RESOLUTION 2013-24

A RESOLUTION APPROVING A DEVELOPMENT PLAN FOR THE VILLAGE AT WEST MAIN PUD SUBDIVISION, LOCATED AT 1319 WEST MAIN STREET, BY THE CITY OF FRANKLIN, TENNESSEE.

SUBJECT: Resolution 2013-24, a resolution to approve the development plan for the Village at West Main PUD Subdivision on ± 1.45 acres for the property located at 1319 West Main Street

Nearby building setbacks

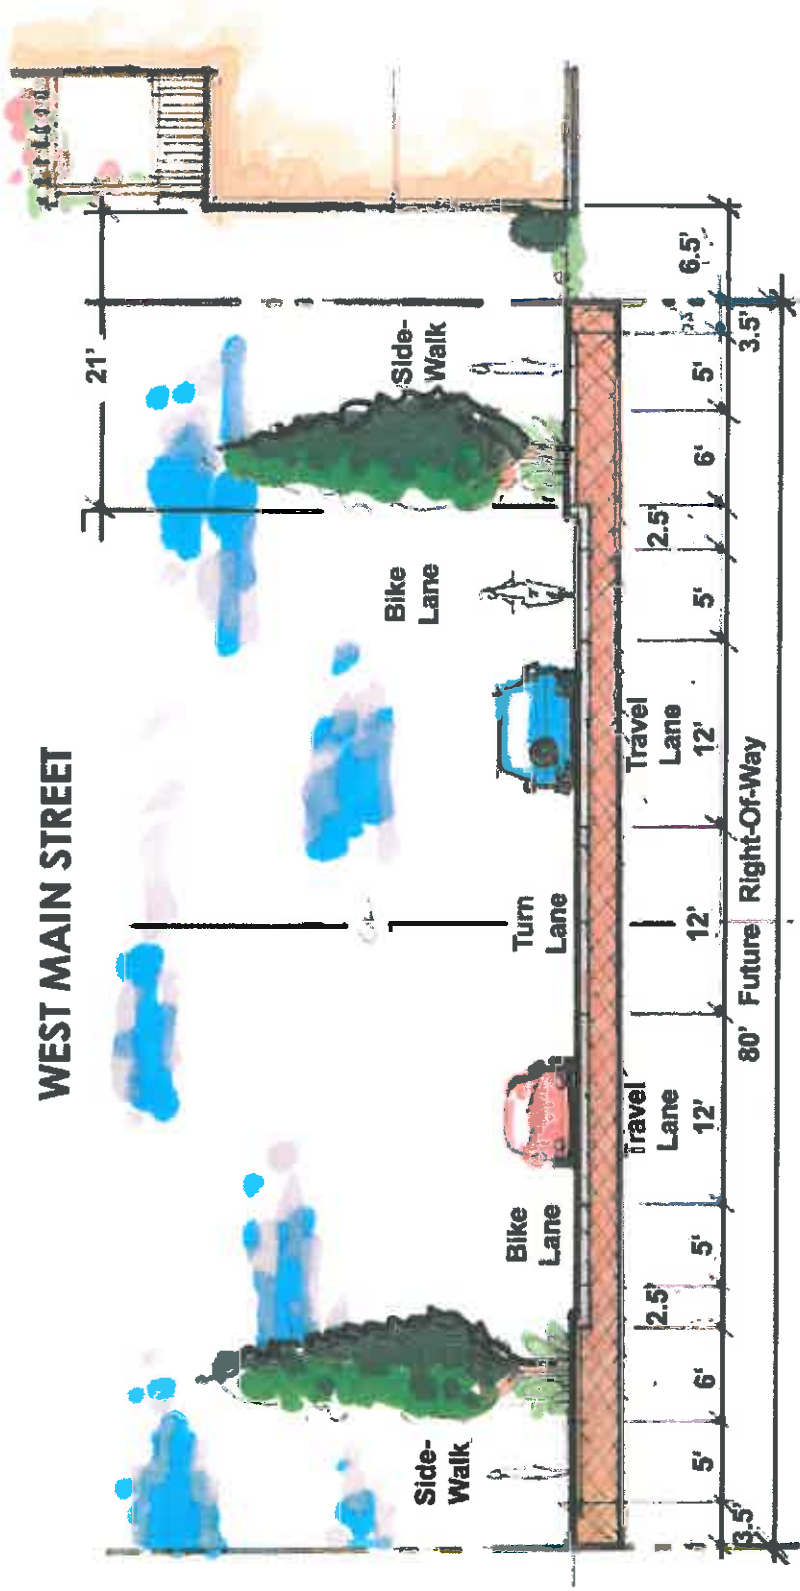
setbacks among neighboring properties vary widely. The structure to the west of this property has a front setback of more than 100 feet, while the two structures to the east are set back approximately 30 feet from West Main. The two structures on the north side of West Main, directly across the street from the applicant's property, have front setbacks of 20 feet and 215 feet, respectively.

Staff agrees with the applicant that a balance between the existing context of West Main and the traditional design standards is most desirable. The applicant proposes a front setback of 15 feet in order to accomplish this balance. A setback of 15 to 20 feet is optimal for this project. Staff recommends approval of Modification of Standards request #1.
